Document	Fishtek Responses to NatureScot Technical Queries
Project	Glen Earrach Energy – Dochfour Weir Fish Passage
Date	06/05/2026
Version	1.0
Author(s)	Paul Gratton
Reviewer(s)	Toby Coe

This standalone technical note provides responses to NatureScot’s clarification points of 23 April 2026 in relation to fish passage and construction-phase fish passage continuity at Dochfour Weir. It should be read in conjunction with the March 2026 River Moriston SAC submission pack, including the Fishtek Optioneering Summary Rev 004, the Temporary Fish Passage Technical Note and associated drawings.

Image taken - 06/02/2026

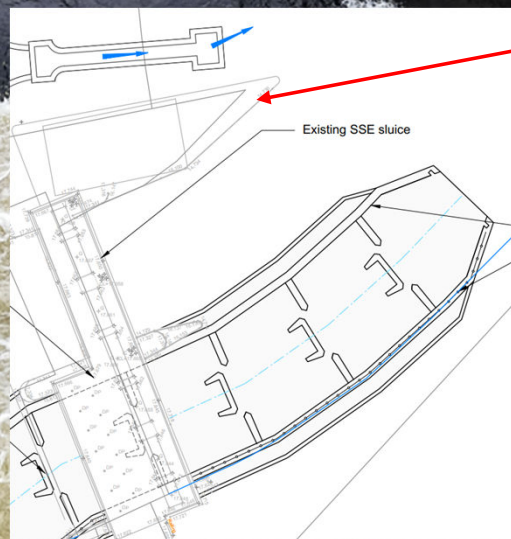
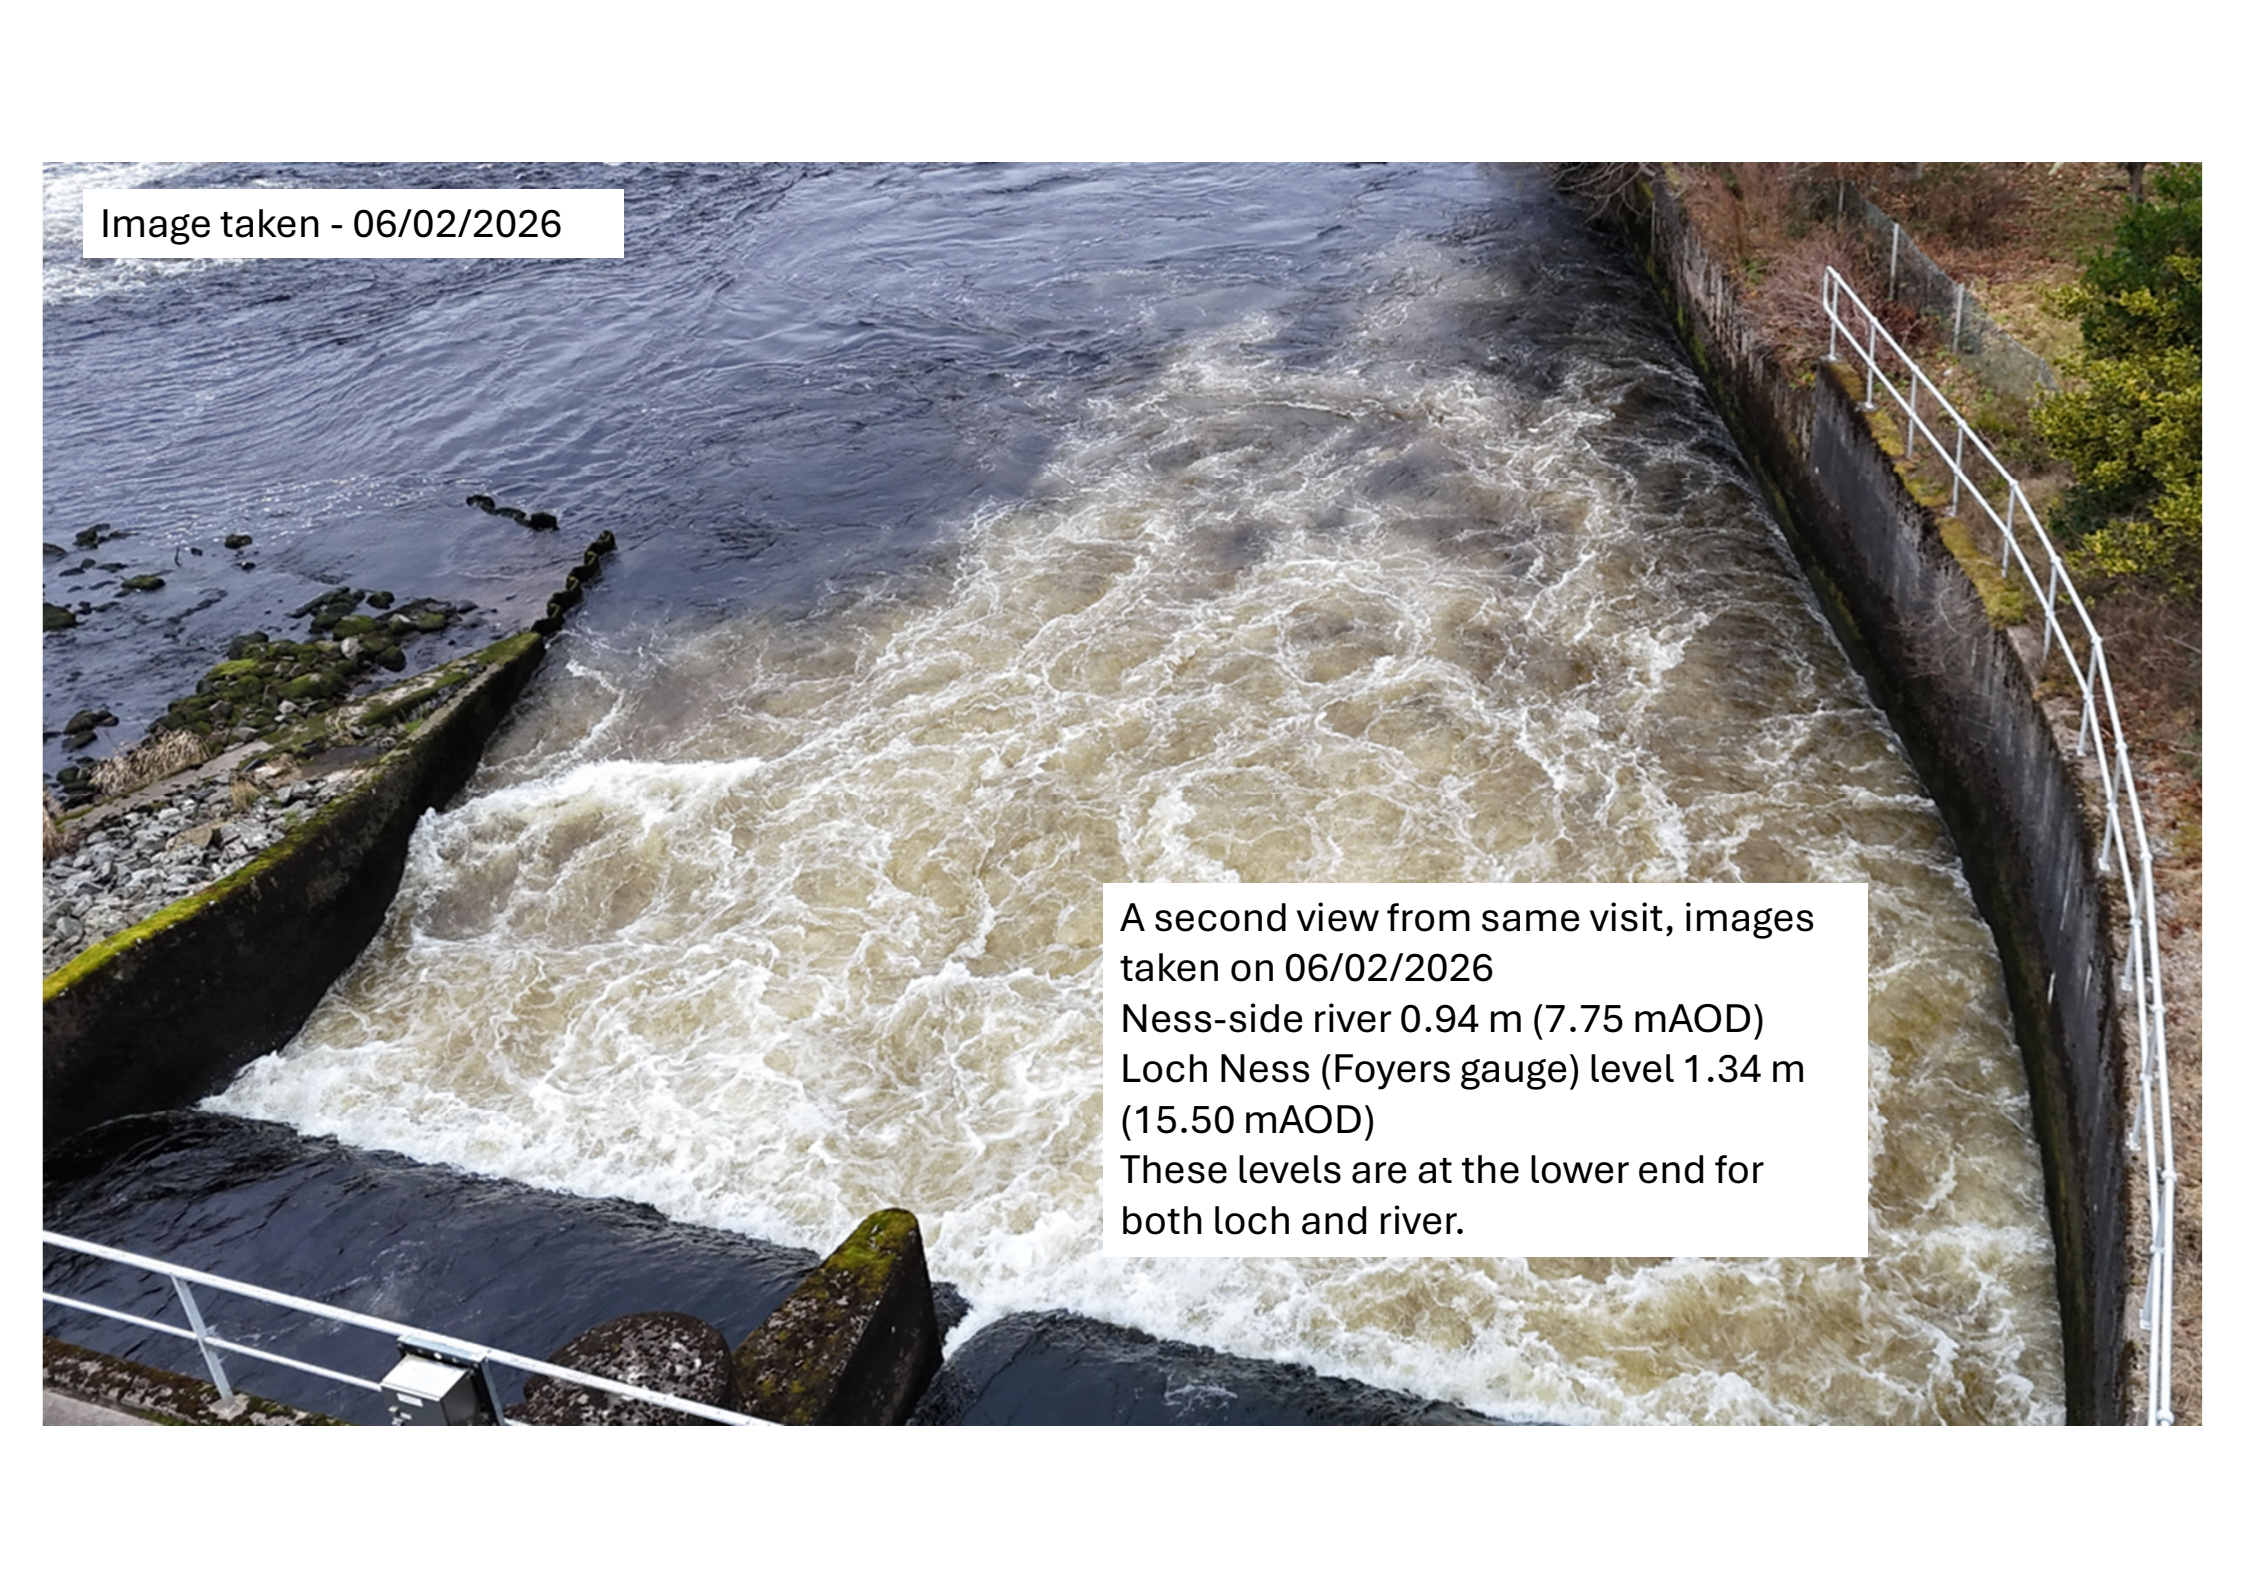
The proposed fish pass design is based on typical downstream water level derived from the design drawings of the previous temporary fish pass operated during the 2017-18 canal repairs. It is not clear how those water levels were derived at the time, nor whether the fish passage option proposed now would still be feasible should the values shown on the 2017-18 drawings prove to be different to current conditions. We therefore advise you undertake sensitivity analysis to show the implications of deviations from the estimate of downstream level on the design of the fish pass that would still meet the requirements in Table A1. If this analysis shows that additional sections would be required in the fish pass, are there any physical constraints to the overall footprint of the pass that would render it unfeasible? Please also provide some empirical evidence of a downstream water level immediately below the weir from which to base the sensitivity analysis.

conditions on 6 February 2026, the downstream tailwater is visually estimated at approximately 14.4–14.5 mAOD. Under a higher loch-level condition on 14 November 2025, with the SSE sluice not open, the same reference point indicates a higher tailwater level of approximately 14.8–14.9 mAOD.

These observations support the conclusion that the 14.40 mAOD level used in the previous temporary fish pass drawing remains a reasonable and conservative lower-bound design assumption for the present concept-stage. The photographic scaling exercise should be treated as indicative observational evidence rather than a substitute for continuous instrumented water-level monitoring.

From this image it can be visually estimated that tailwater is about 0.2-0.3m below the surveyed point, so around the 14.4-14.5 mAOD level.
